**SUBJECT:** Addendum No. 3

**REFERENCE:** Invitation To Bid (ITB) for Rehabilitation of Taxiways SA & SB at IAH; Solicitation No. HJA-TXSASB-2024-020; Project No. 0646A

- I. **Replace** Document 00410 **with Revised Document 00410 – Bid Form**
- II. **Replace** Drawings Civil Section C03.01, C10.04, and C10.05 **with Revised Drawings Civil Section C03.01, C10.04, and C10.05.**
- III. **Respond** to questions.

**4**  
C03.01  
**PROPOSED CONCRETE TAXIWAY TYPICAL SECTION**  
SCALE: NONE

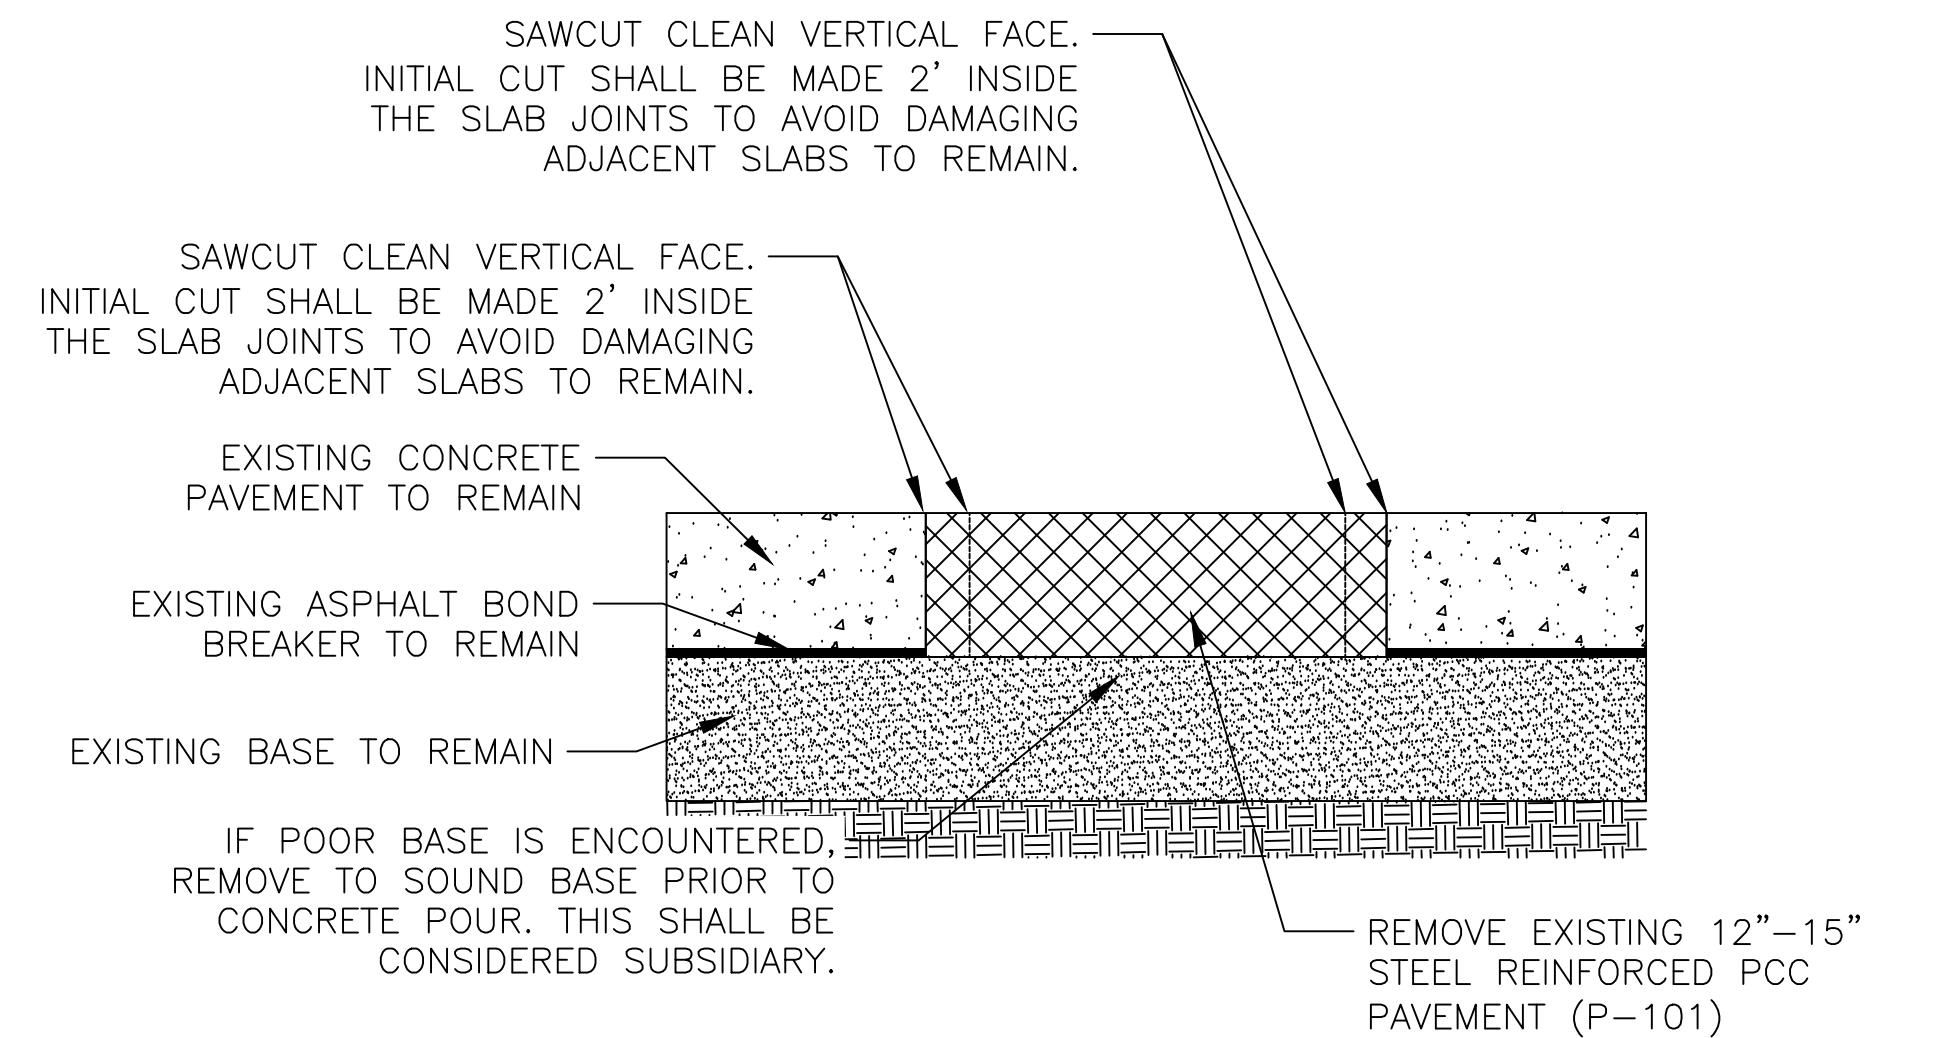
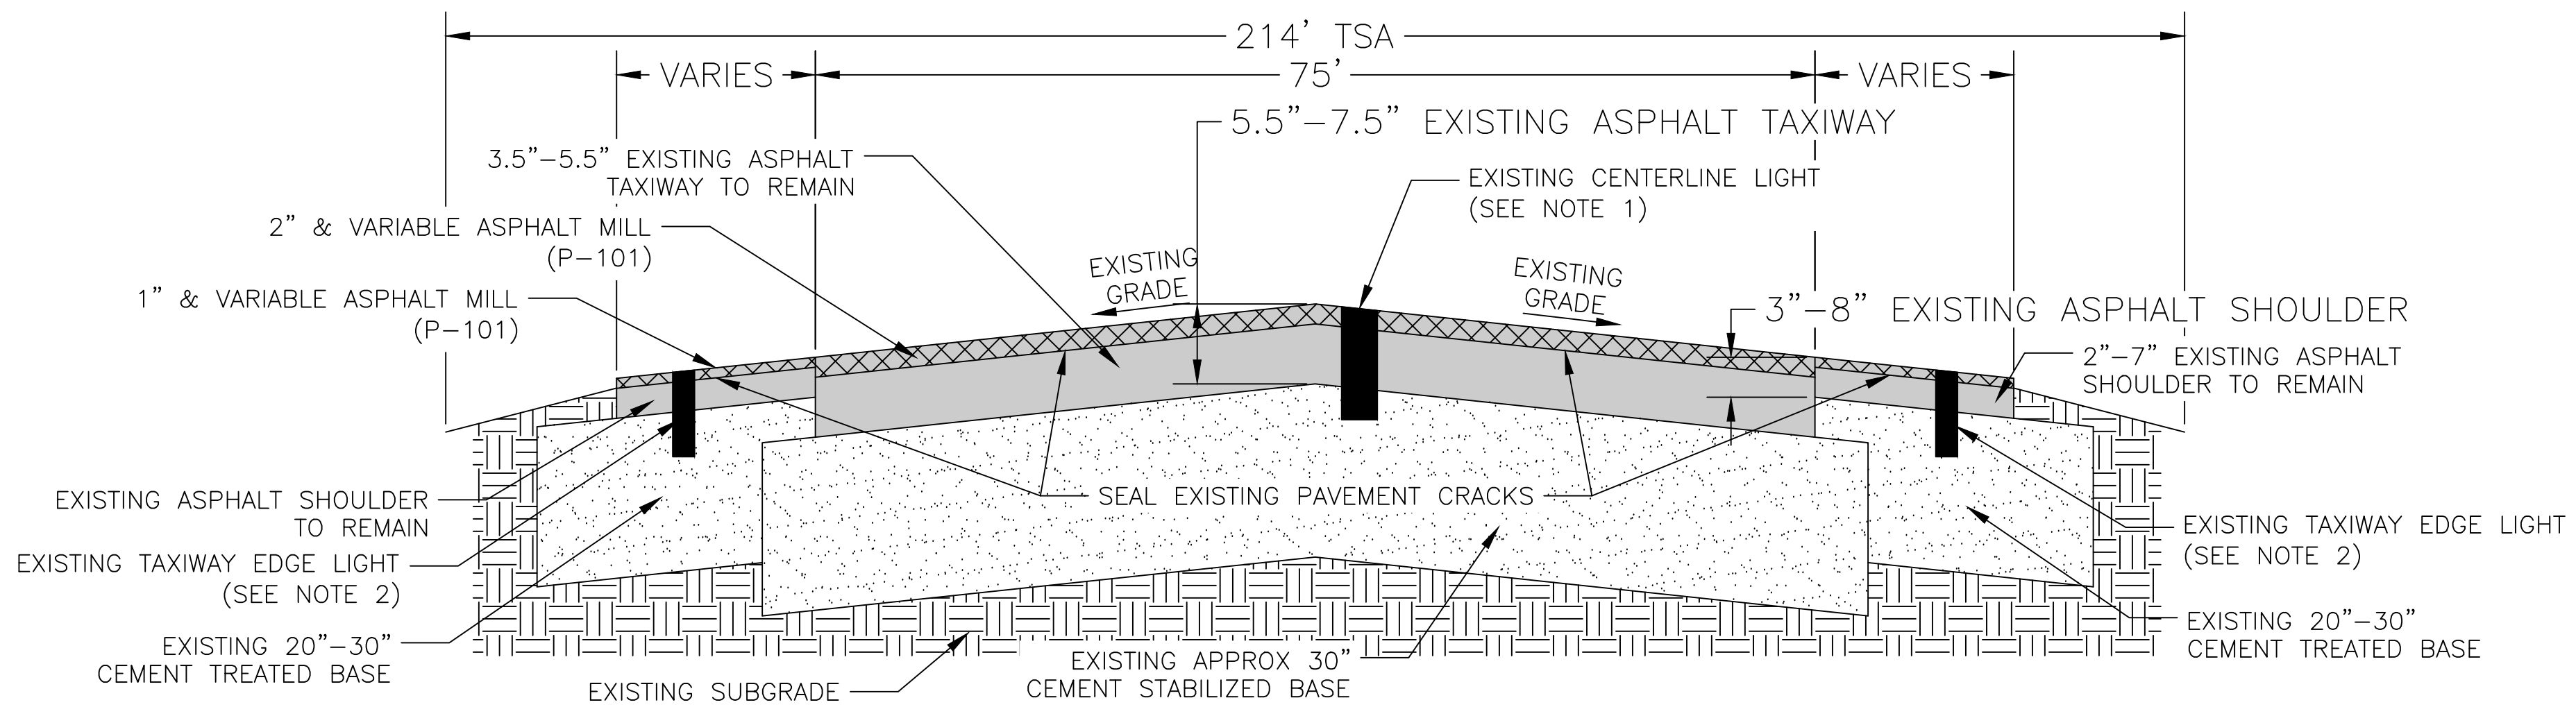
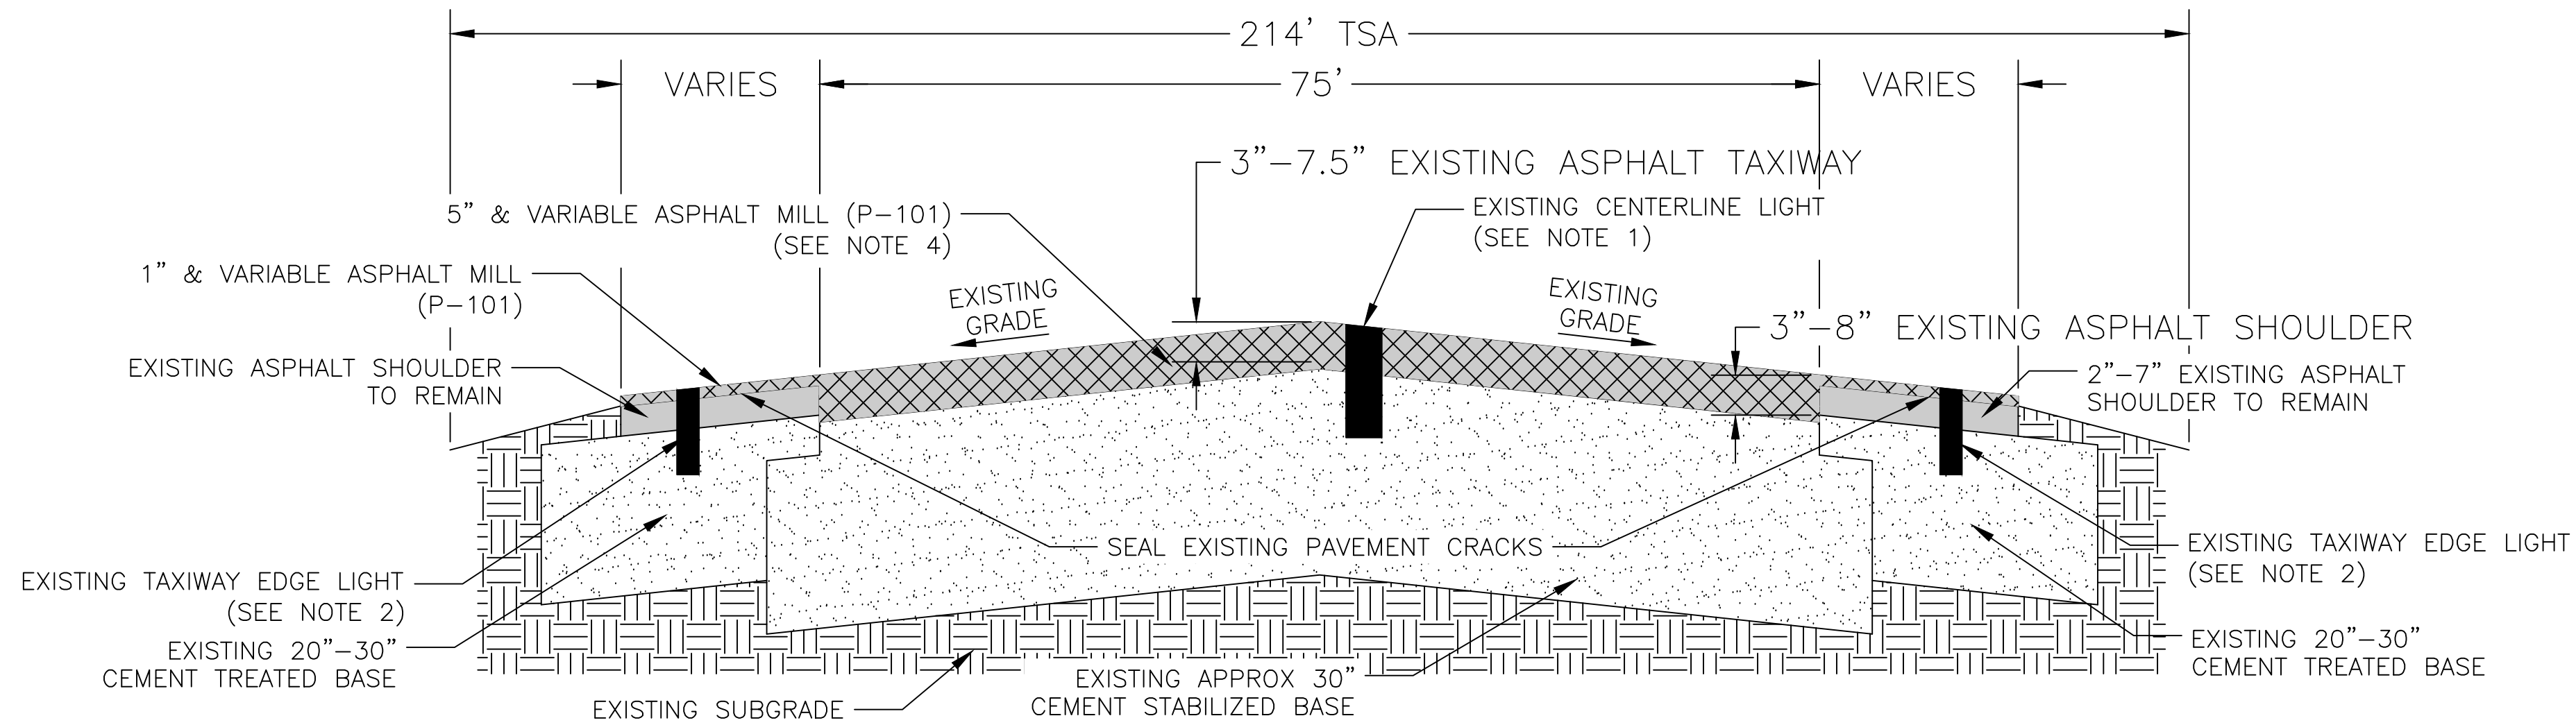
8. **Question:** What is the thickness of bond breaker (per sheet C03.01)?

10. **Question:** Per Details 4 at Sheet C03.01 and Details 2 and 4 at sheet C3.02 show the 2' of Crushed Aggregate Base Extension, is this extended measurement of quantity of base accounted on the bid item # 41 (P-209-5.2) or is it incidental/ subsidiary to that item? Please clarify.

**Response:** Bond breaker should be a minimum of 1-inch in thickness.

**Response:** Yes, it is accounted for in P-209.
